UNITED STATES PATENT AND TRADEMARK OFFICE

10/780,718

Office Action Summary

Drawings

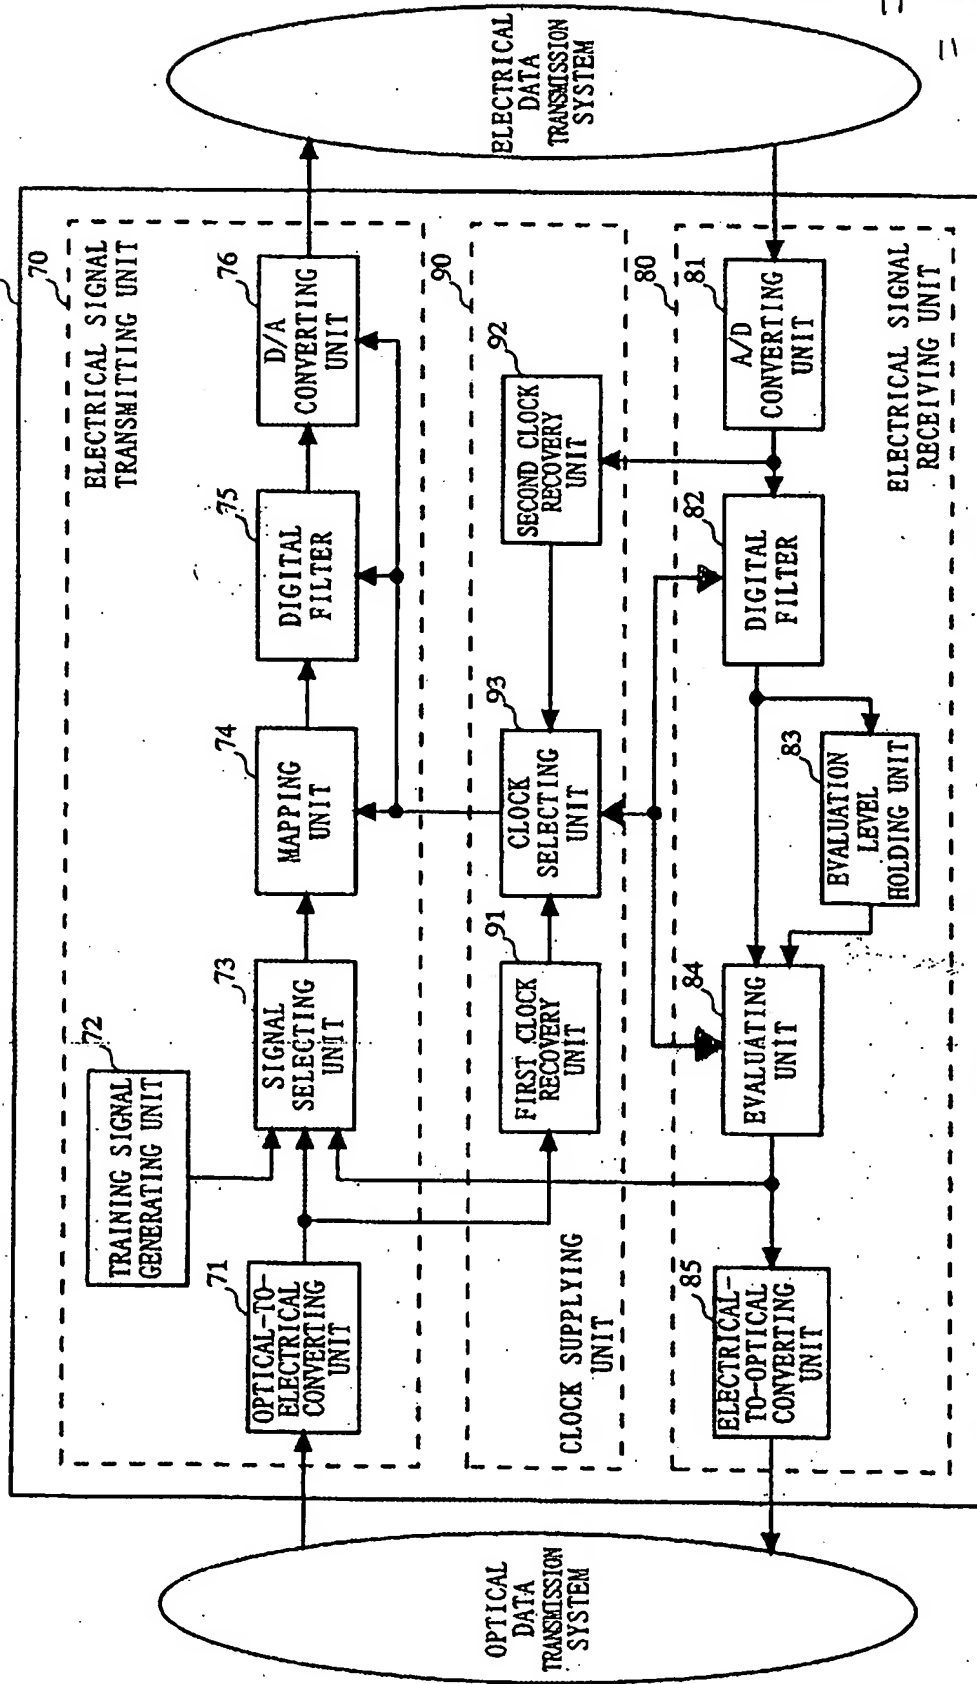
2. Applicant's response to the objection to the drawings in the previous Office Action (mailed on 09 February 2007) is noted and appreciated. Replacement drawings for Figs. 6-9 were received on 23 May 2007. However, these drawings are disapproved. These replacement drawings for Figs. 6-9 include a ***bidirectional*** link between clock selecting unit 93 and evaluating unit 84 and digital filter 82. However, Applicant's disclosure may only support a ***unidirectional*** link from clock selecting unit 93 to evaluating unit 84 and to digital filter 82.

The emphasized limitations suggest that Figs. 6-9 should show "electrical signal receiving unit" 80 with some input from "clock selecting unit" 93, but not an input to "clock selecting unit" 93 from evaluating unit 84 or from digital filter 82. Otherwise, the drawings include new subject matter that is not supported by Applicant's original disclosure. As a remedy, Examiner respectfully suggests drawing

amendments that reflect the end of Applicant's paragraph [0044], which notes that the "processes by the digital filter 82 and the evaluating unit 84 are basically performed in accordance with the clock output from the clock selecting unit 93". That is, Examiner respectfully suggests a **unidirectional** link from clock selecting unit 93 to evaluating unit 84 and to digital filter 82.

FIG. 6

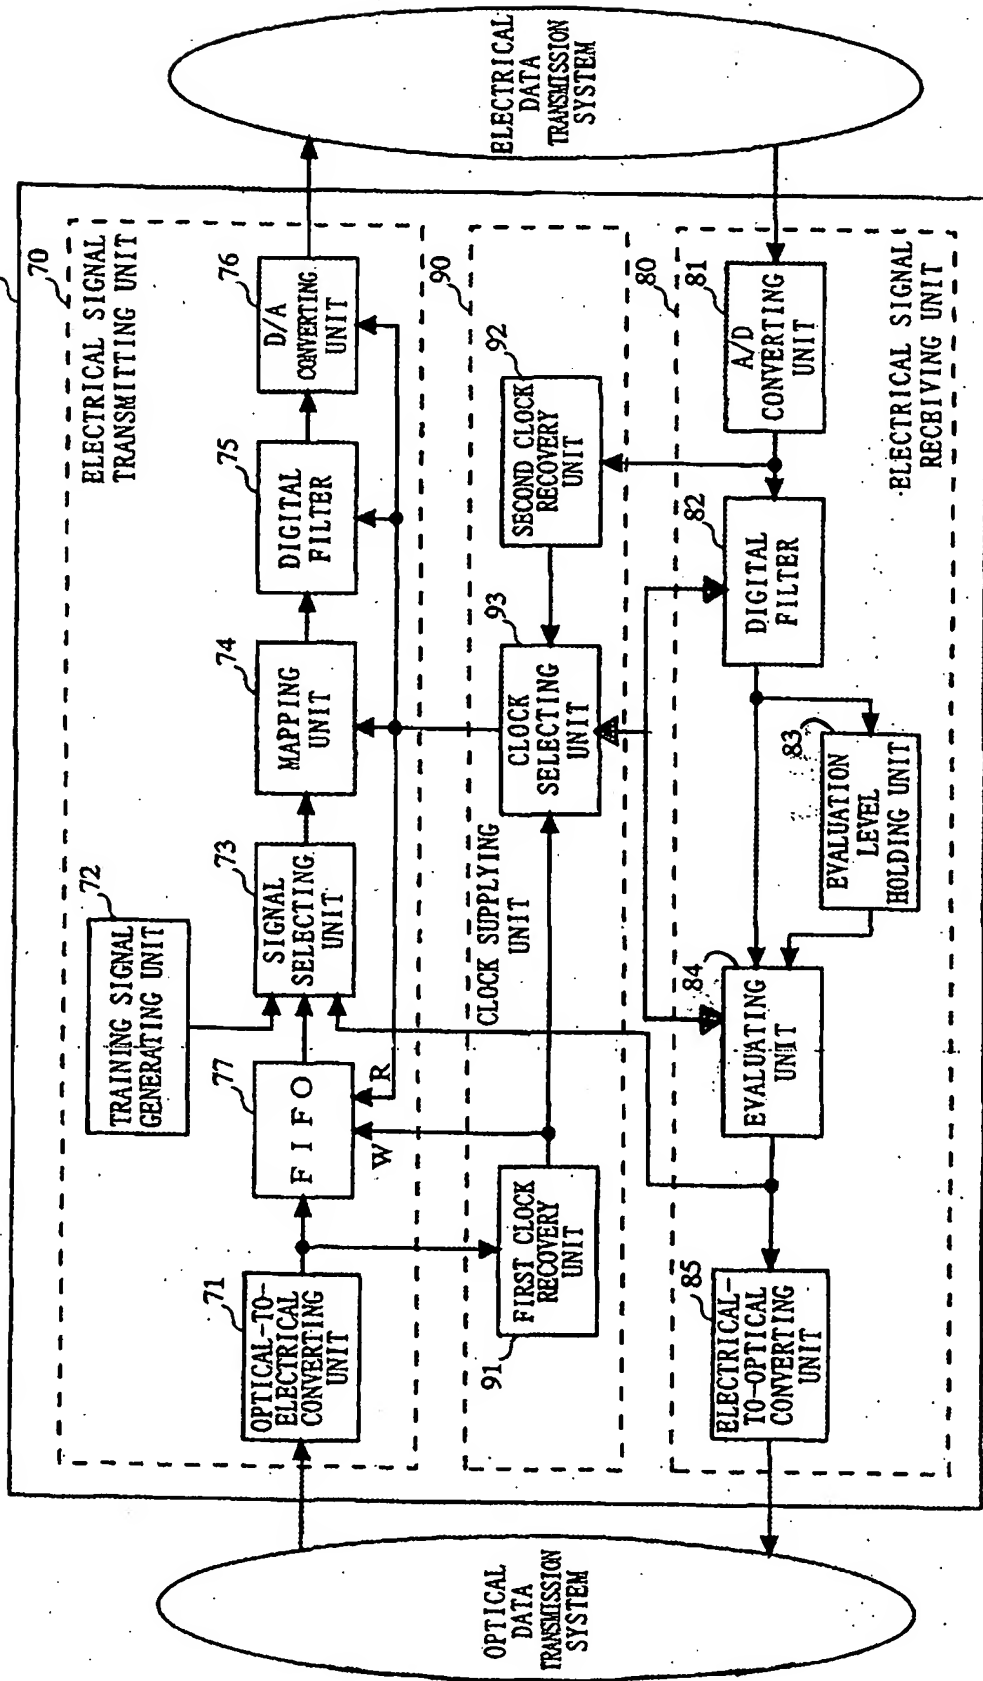
Disapproved by DSK
11 AUGUST 2007

FIG. 7

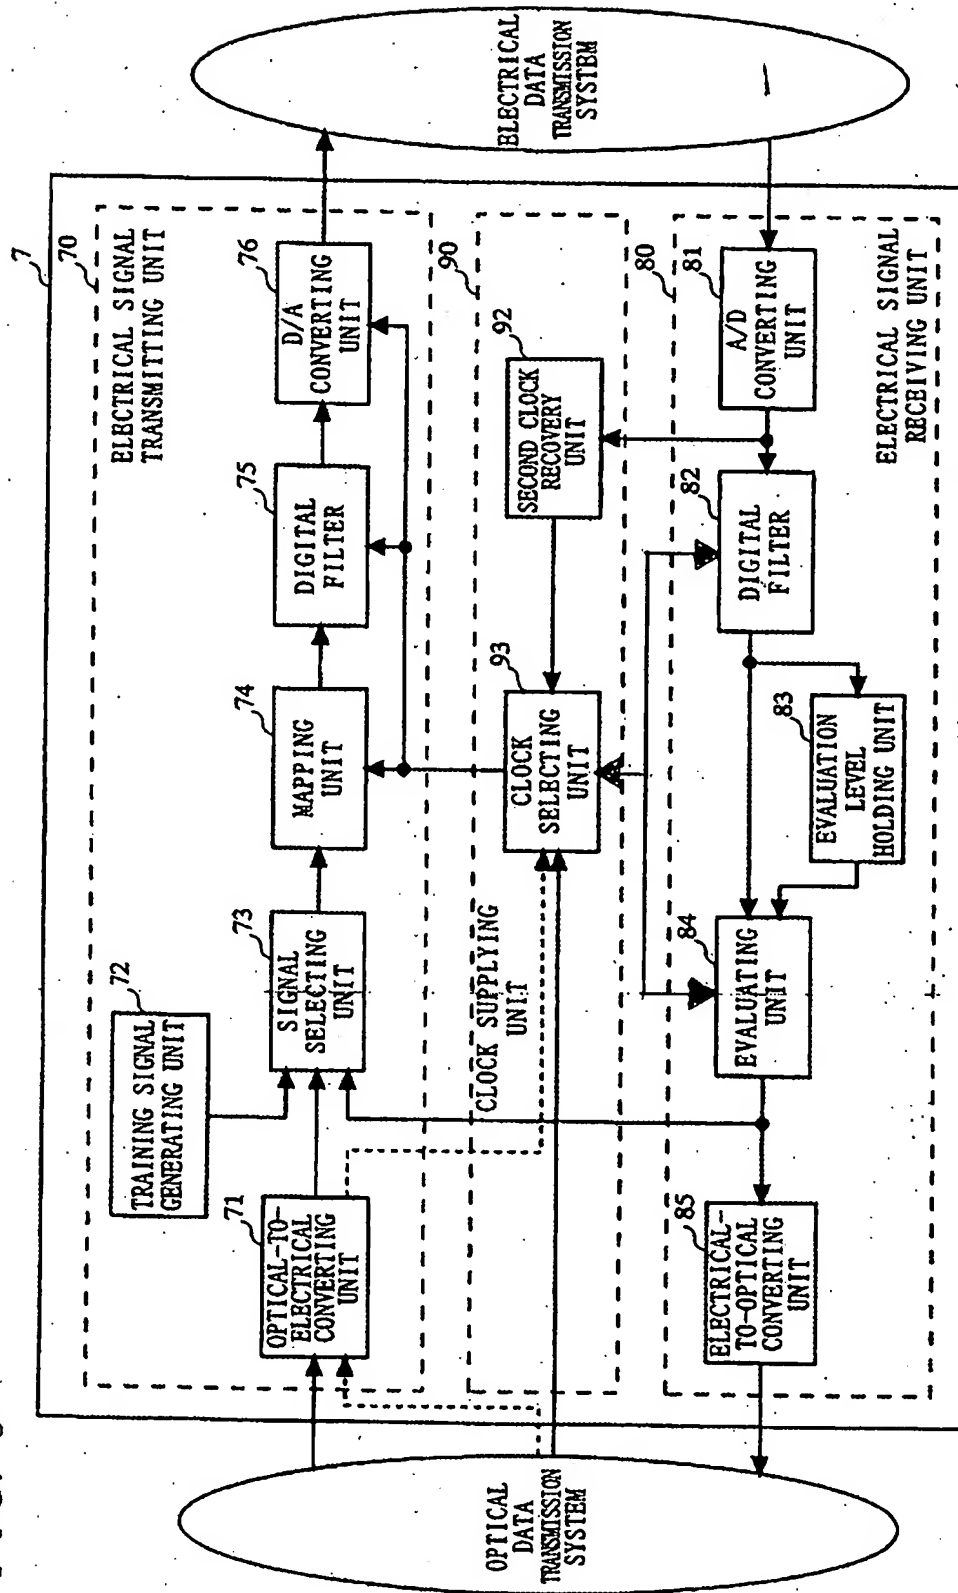
Disapproved by Dsk
11 August 2007
